Z-35
(2013)

PROJECT NAME:
 3993-4021
 SHALLOWFORD
 SUBDIVISION
 OWNER OR CLIENT:
 RICHARD DUNN

PETITION NO: Z-35

ZONING COMMENTS:

SCALE: 1" = 40' (FULL SCALE)
 FULL SCALE 1" = 40'
 DRAWING TITLE:
 ZONING PLAN

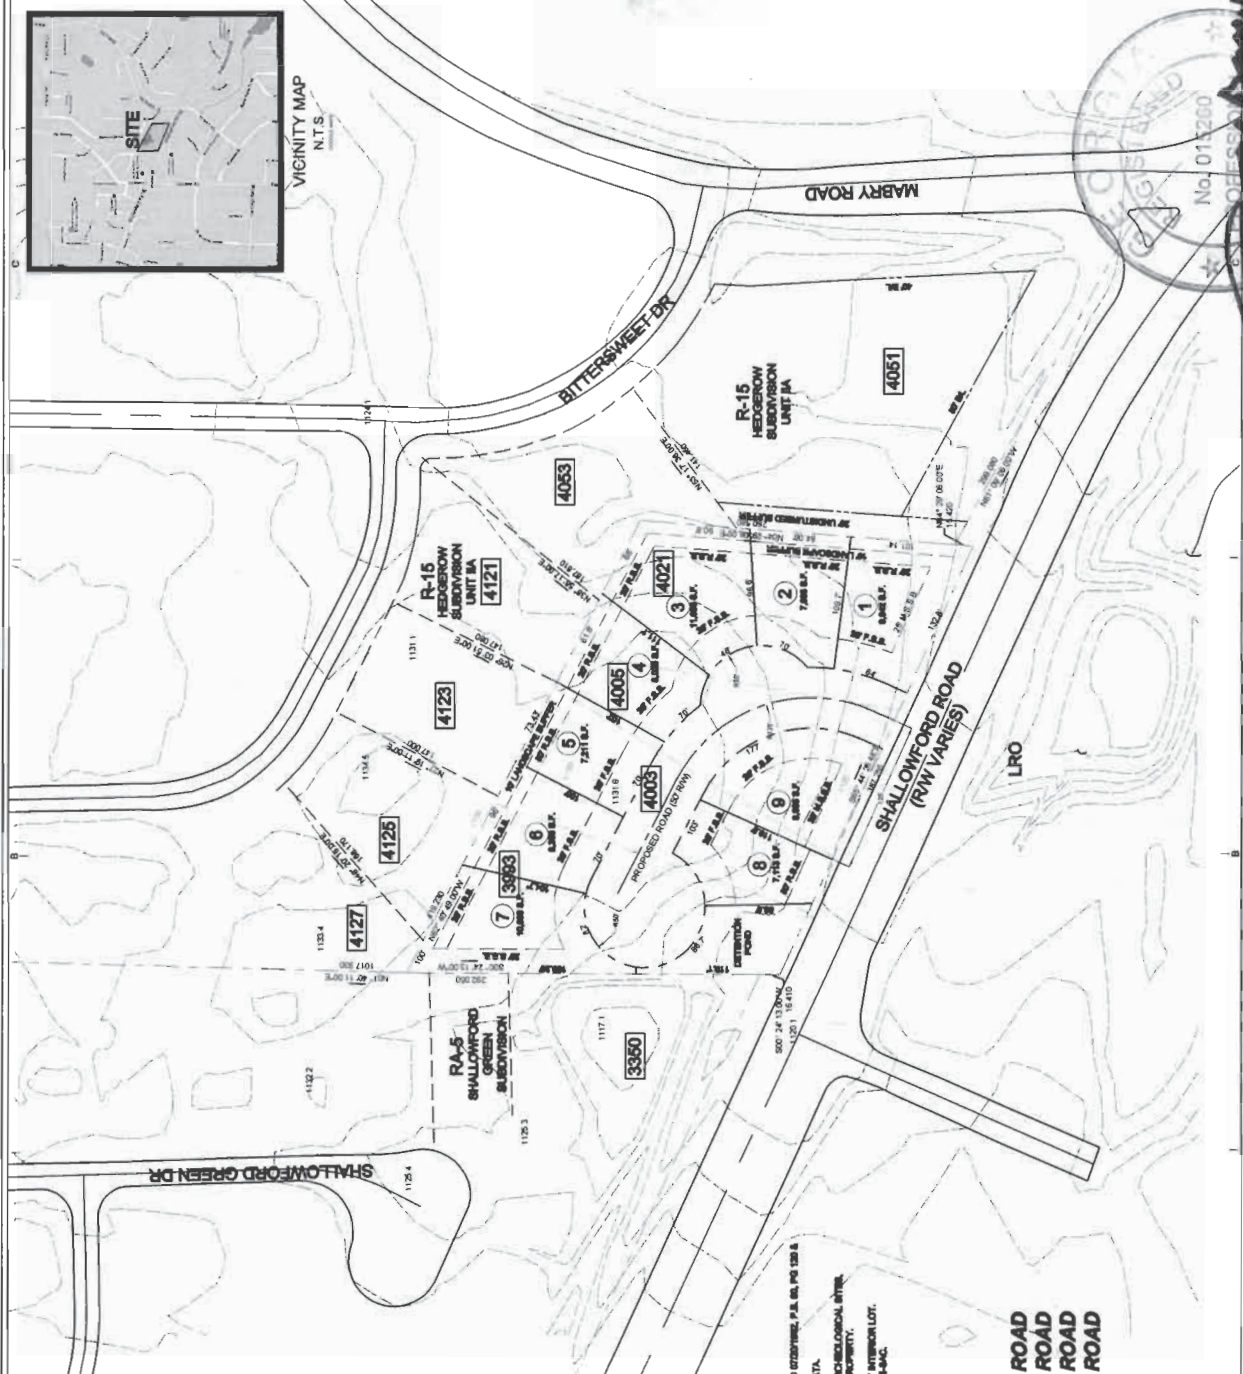
- Provide comprehensive hydrology/stormwater controls to include development of out parcels.
- Submit all proposed site improvements to Plan Review.
- Any **spring activity** uncovered must be addressed by a qualified geotechnical engineer (PE).
- Structural fill _____ must be placed under the direction of a qualified registered Georgia geotechnical engineer (PE).
- Existing facility.
- Project must comply with the Water Quality requirements of the CWA-NPDES-NPS Permit and County Water Quality Ordinance.
- Water Quality/Quantity contributions of the existing lake/pond on site must be continued as baseline conditions into proposed project.
- Calculate and provide % impervious of project site.
- Revisit design; reduce pavement area to reduce runoff and pollution.

- No Stormwater controls shown _____
- Copy of survey is not current – Additional comments may be forthcoming when current site conditions are exposed.
- No site improvements showing on exhibit.

1. This site is located just north of Shallowford Road and is bounded on the north and east by Hedgerow Subdivision and on the west by Shallowford Green Subdivision. Slopes on the site are relatively mild ranging from 2 to 10%. The majority of the site (2/3) drains to the Shallowford Road R/W. The remaining third drains to the east into the Hedgerow Subdivision Recreation Area.
2. Any bypass runoff from the rear of lots 1 through 7 must be directed to the Shallowford Road right-of-way and not to the Hedgerow Rec Area.

Shallowford Road is classified as an arterial and according to the available information the existing right-of-way does not meet the minimum requirements for this classification.

Recommend applicant consider entering into a development agreement pursuant of O.C.G.A. 36-71-13 for dedication of the following system improvements to mitigate traffic concerns: a) donation of right-of-way on the north side of Shallowford Road, a minimum of 50' from the roadway centerline.

Recommend curb and gutter along both sides and sidewalk along one side of proposed development roadway.

Recommend a deceleration lane on Shallowford Road for the entrance.

Recommend removing and closing driveway aprons along Shallowford Road frontage that development renders unnecessary.
